# Access Compliance Report

## Public Rights-of-Way

### (Curb Ramps)

Intersection ID: 12728	Main Street: E_10TH_ST	Cross Street: SEIGLE_AV	Location: S
ADA ID: 537AD1DD754F	Ramp Type: PerpDiag	Initial Pass/Fail: Fail	Overall Compliance: No
		Severity Score: 50

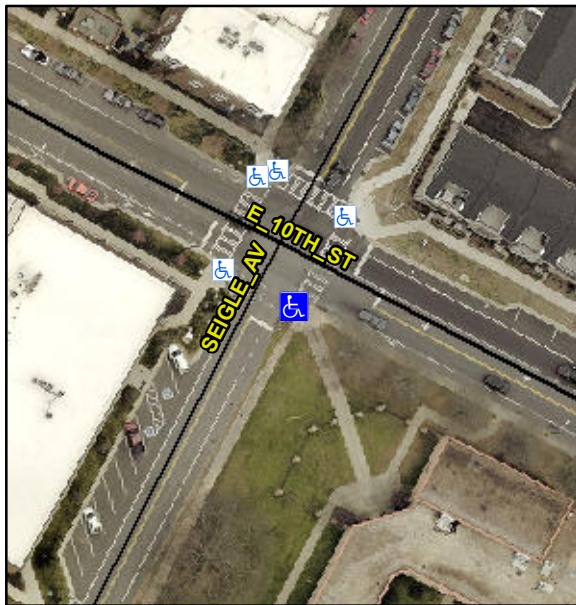
**R304.2.2, R304.5.3**

Compliance	Description	Data	Compliance	Description	Data
N/A	Ramp Length (in)	47.0	No	Ramp Slope (%)	12.0
Yes	Ramp Width (in)	60.0	No	Ramp XSlope (%)	8.0
N/A	Flare Type LT	N/A	N/A	Flare Type RT	N/A
N/A	Flare Slope LT (%)	N/A	N/A	Flare Slope RT (%)	N/A
N/A	Flare Traversable LT?	N/A	N/A	Flare Traversable RT?	N/A
N/A	Landing Length (in)	N/A	N/A	DWS Provided?	N/A
N/A	Landing Width (in)	N/A	N/A	DWS Contrast?	N/A
N/A	Landing Slope (%)	N/A	N/A	DWS Length (in)	N/A
N/A	Landing X Slope (%)	N/A	N/A	DWS Full Width?	N/A
N/A	Landing Curb? (Y/N)	N/A	N/A	DWS Offset (in)	N/A
N/A	Shared Landing?	N/A			
N/A	Gutter Ponding?	N/A	N/A	Gutter Slope (%)	N/A
N/A	Gutter Lip Ht (in)	N/A	N/A	Gutter X Slope (%)	N/A
N/A	Painted X Walk1?	Yes	N/A	Painted X Walk2?	Yes
	X Walk 1 Direction	To NE		X Walk 2 Direction	To NW
N/A	X Walk 1 Width (in)	110.0	N/A	X Walk 2 Width (in)	87.0
	X Walk 1 Slope (%)	6.2		X Walk 2 Slope (%)	0.2
	X Walk 1 X Slope (%)	2.5		X Walk 2 X Slope (%)	6.3

N/A	Ramp inside XWalk1?	Yes	N/A	Ramp inside XWalk2?	Yes
	Road Slope (%)	6.0	N/A	Clear Space?	N/A
	Road X Slope (%)	4.0	N/A	Clear Space to XWalk (in)	N/A
N/A	Any Obstructions?	N/A	N/A	Storm Grate/Utility Hazard?	N/A
	Obstruction Type			Storm Grate/Utility Type	
		N/A			N/A
		Yes		Surface Condition? (G/P)	Good

**Remove & Replace Curb Ramp With Two New Directional Ramps or Equivalent.**
